CITY PLAN COMMISSION REPORT

Barry Road Townhomes

16 CD-CPC-2022-00075
Development Plan
(w/ preliminary plat)

CD-CPC-2022-00075 - A request to approve a development plan and a preliminary plat for the construction of 86 townhomes in District R-1.5 (Residential 1.5)

PRELIMINARY TREE PLAN
1" = 60'-0"

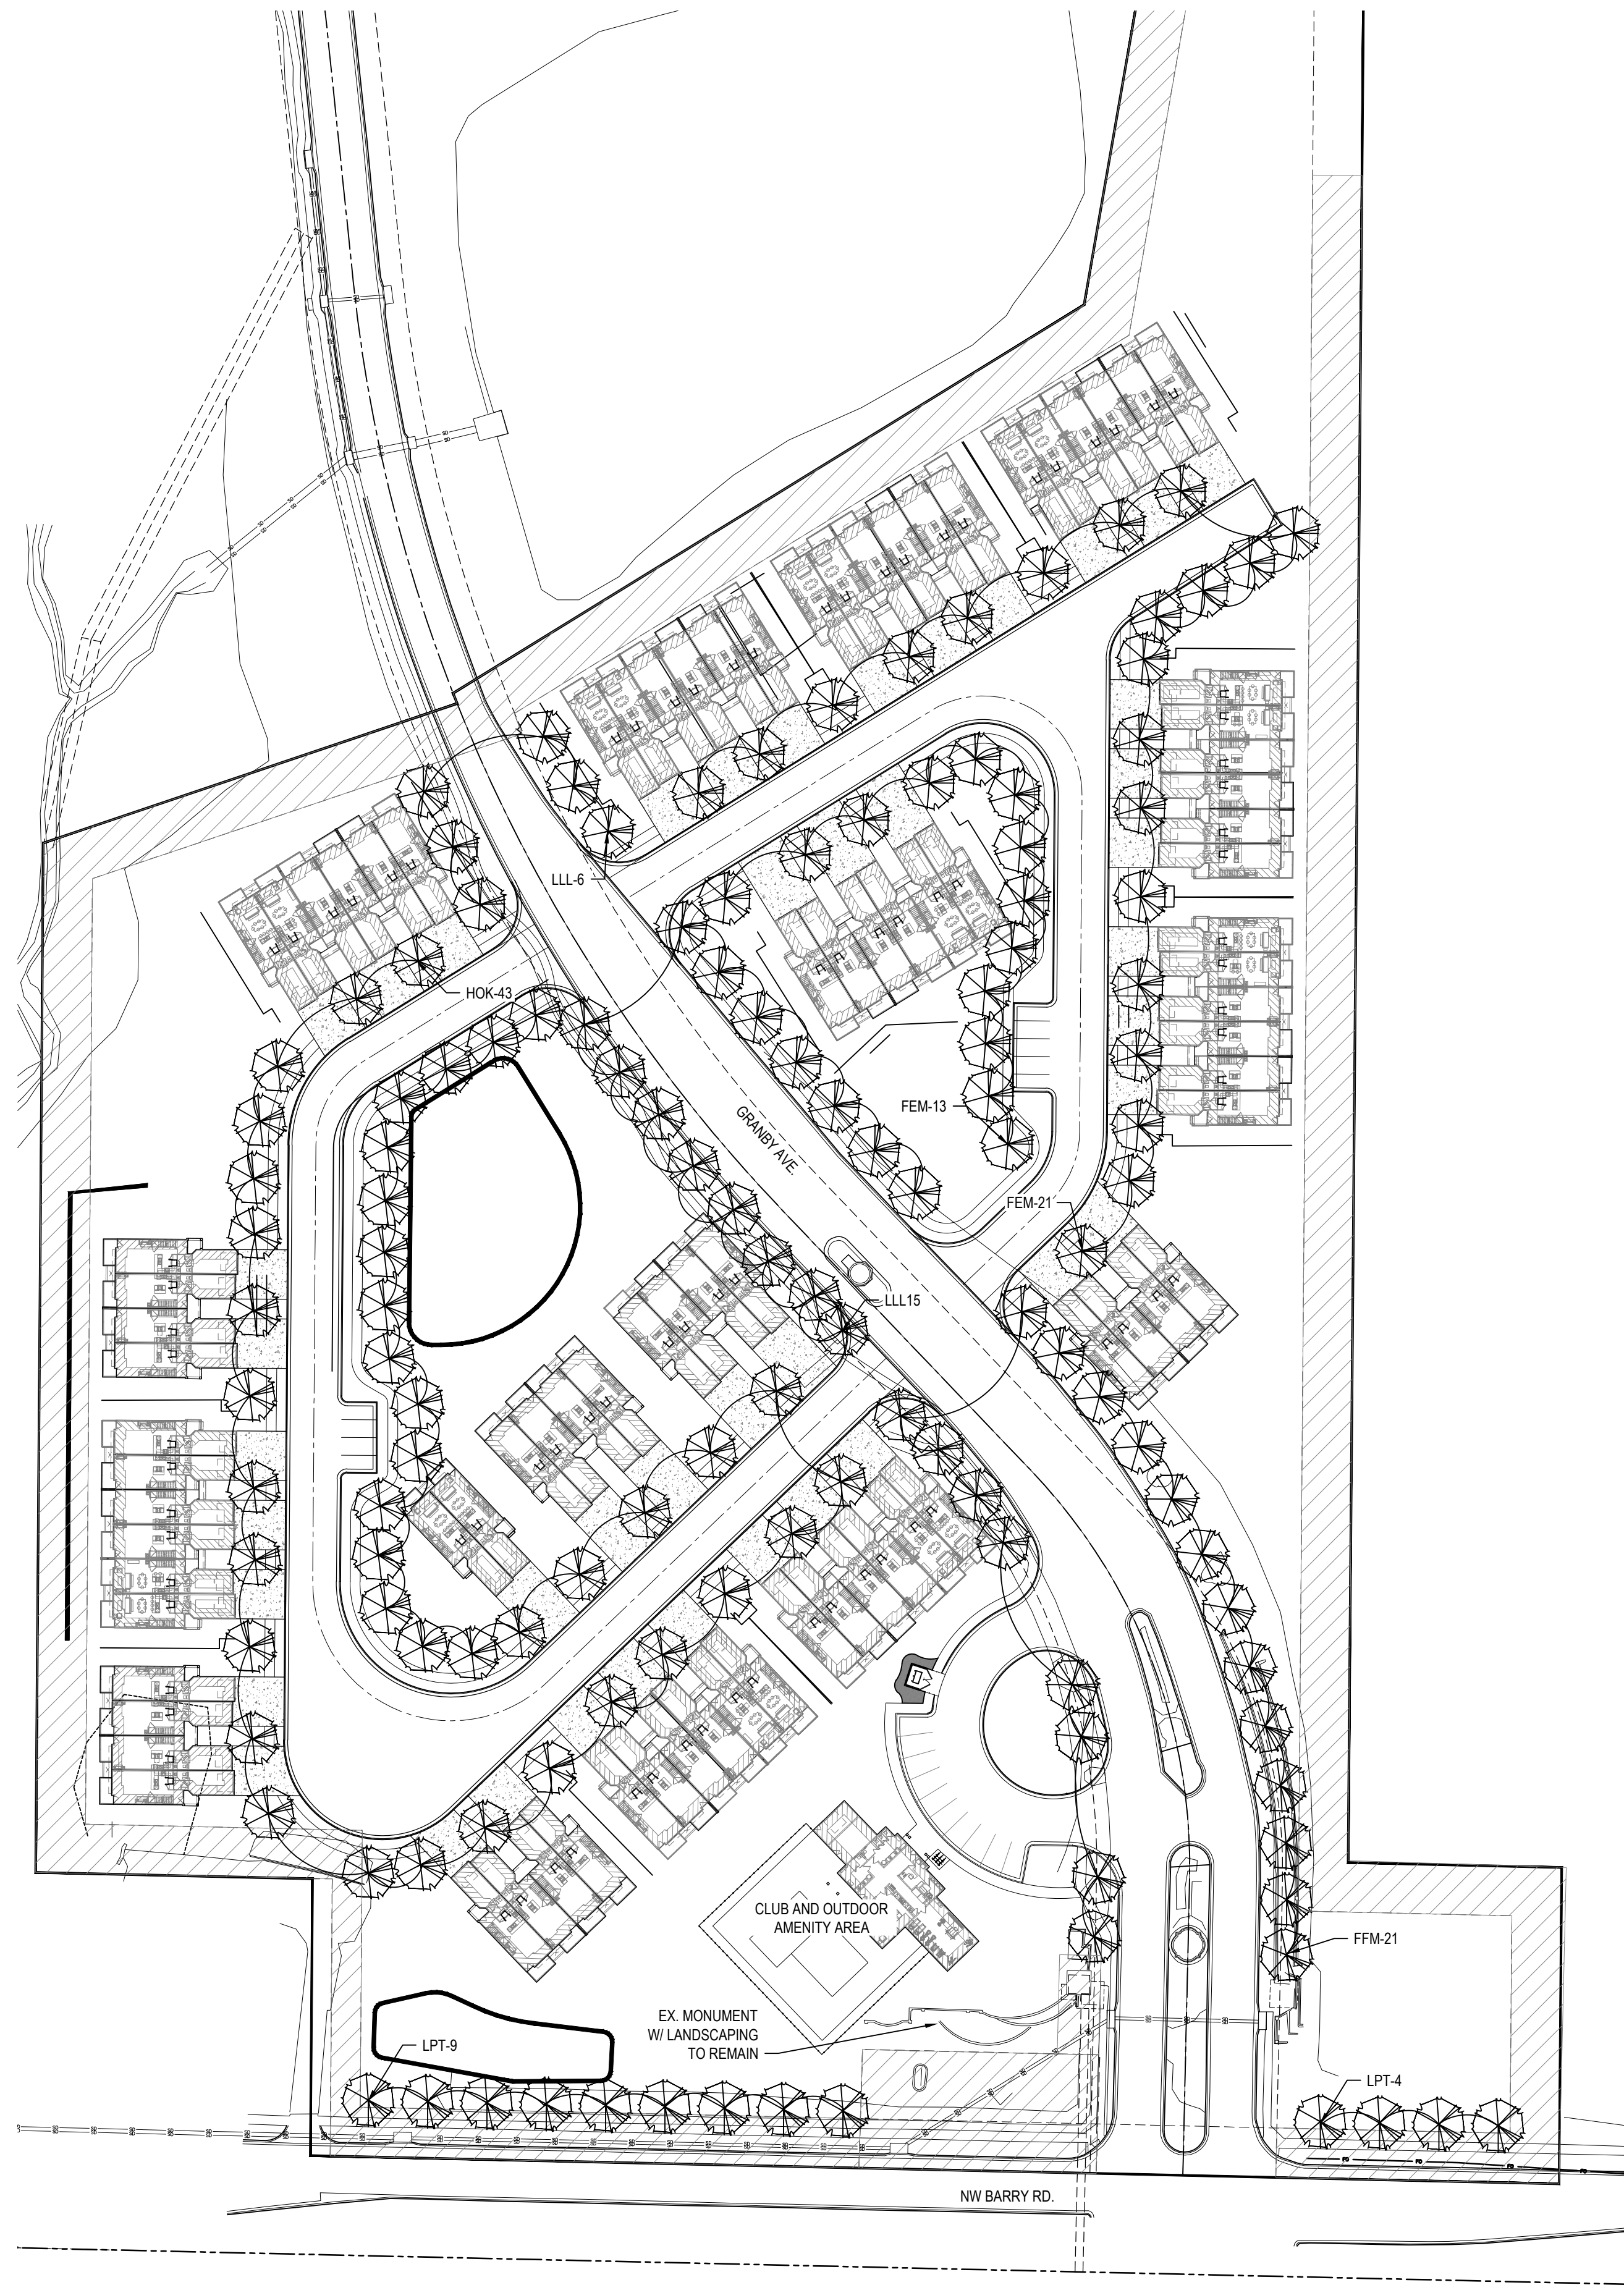
A landscape plan has been submitted by the applicant. The plan is not compliant with Code and will require a deviation to the required amount of street trees (88-425-03). The Code requires a total of 164 trees and the applicant is only proposing 132 trees due to existing easements and intervening roadways; staff does support the administrative adjustment in the reduction of the proposed street trees. The applicant also did not provide staff with the total amount of trees that will be removed due to construction. Staff has conditioned that the applicant provide the total amount of trees that will be removed prior to ordinance request pursuant to (88-516-05-1).

The applicant did not provide staff with the exact number of trees that will be removed which is required by Code.

7. Provide a higher quality lap siding (not vinyl) for any structures visible from Barry Road.
8. Provide number of trees that will be removed for construction pursuant to 88-516 prior to ordinance request.

CLUB FRONT ELEVATION

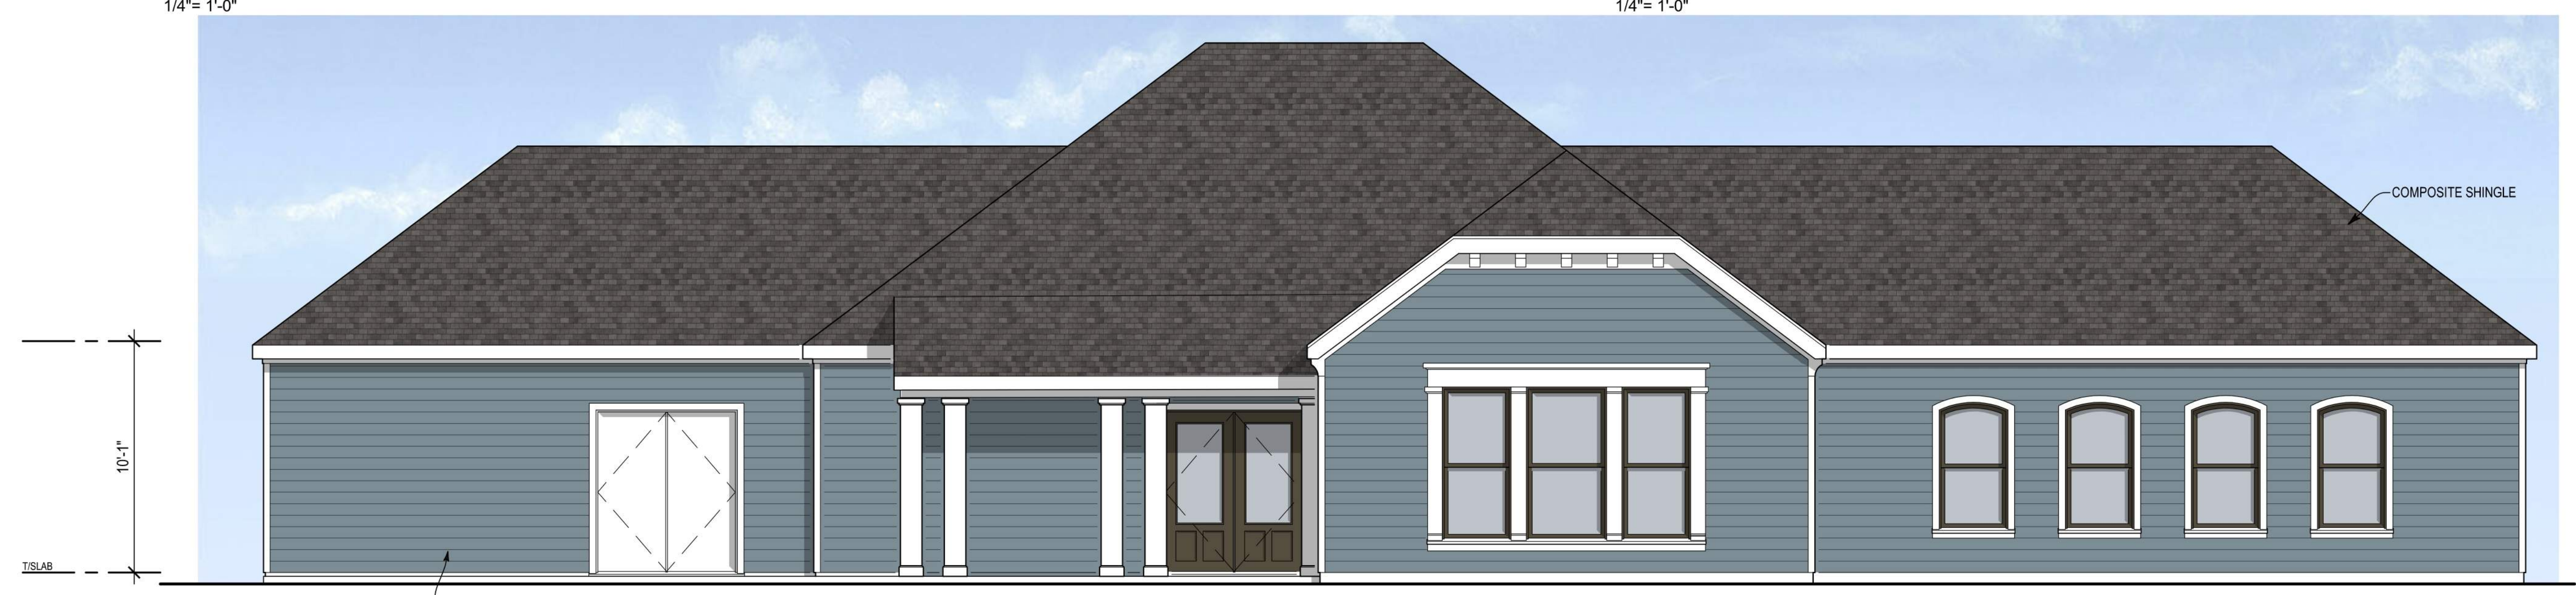
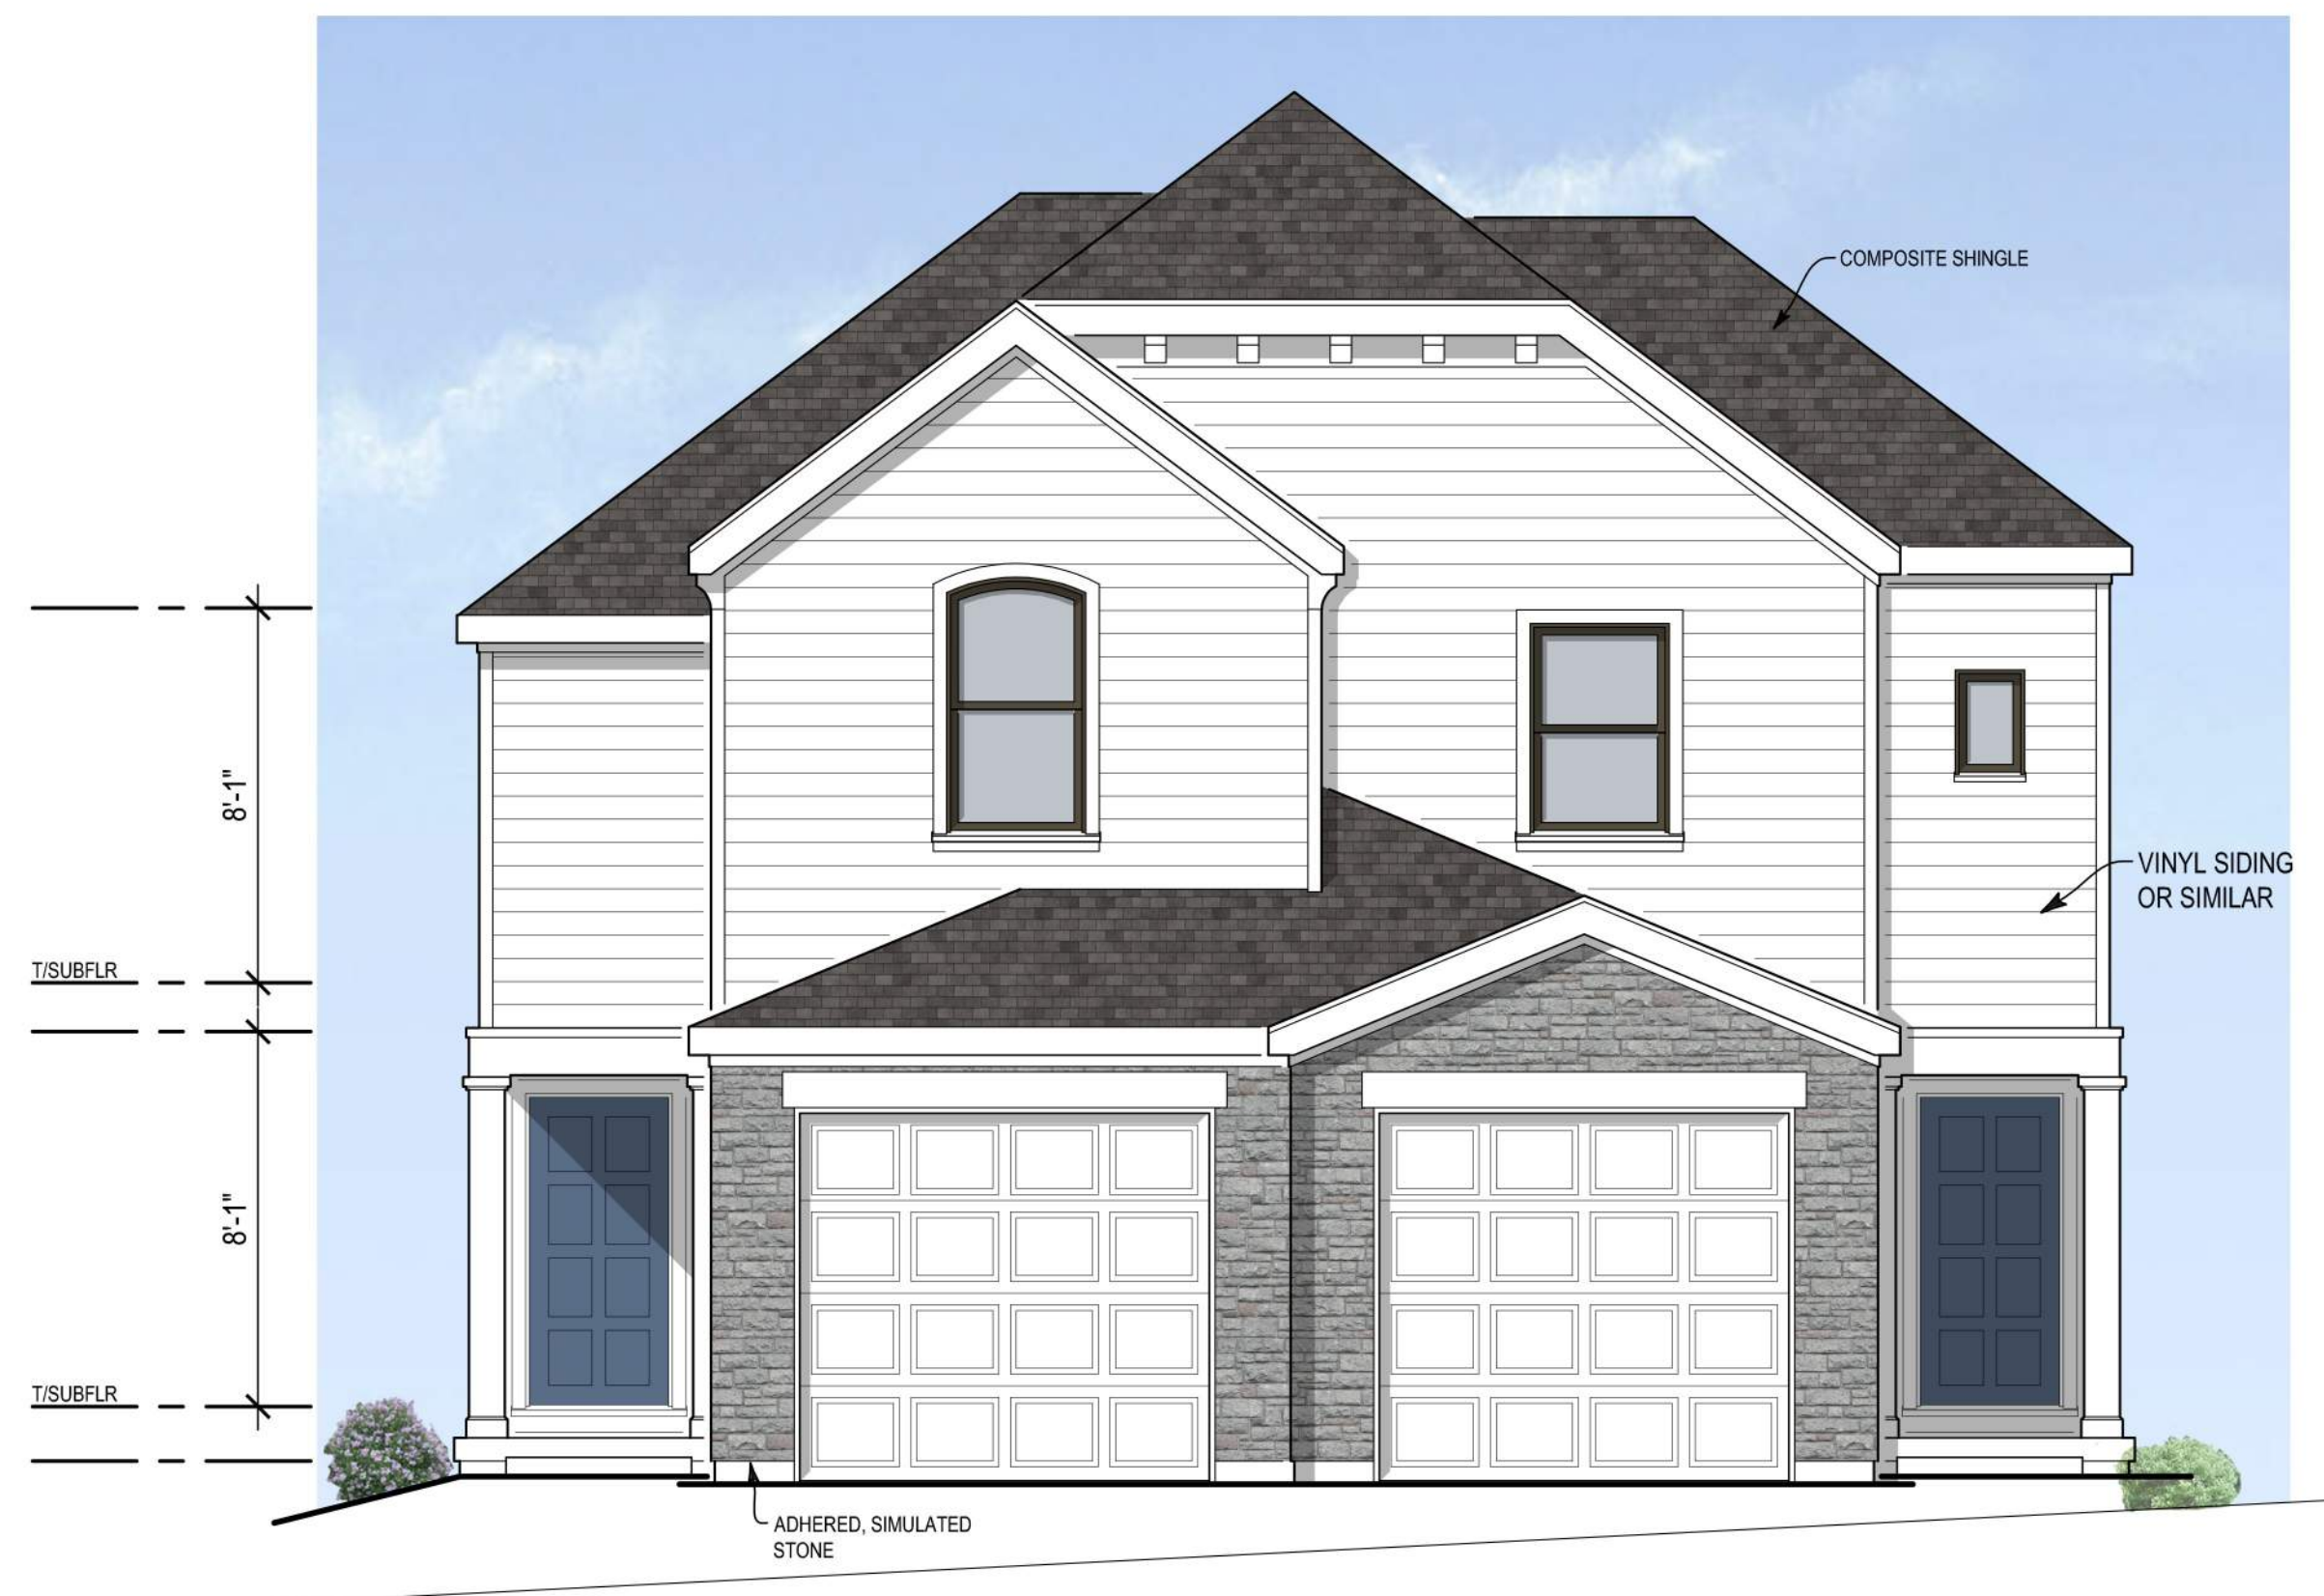
Staff supports the overall design concept and density that the applicant has proposed. The architectural scale and character fits the surrounding area. The primary building materials proposed are white vinyl siding, adhered simulated stone (grey in color), black composite shingles and a dark bronze color for the window frames. Staff does appreciate the number of windows that are being proposed. Staff has requested that the applicant provide a higher quality material such as fiber cement lap siding instead of vinyl. If the applicant cannot provide a higher quality material staff does recommend that the vinyl siding is not visible from Barry Road.
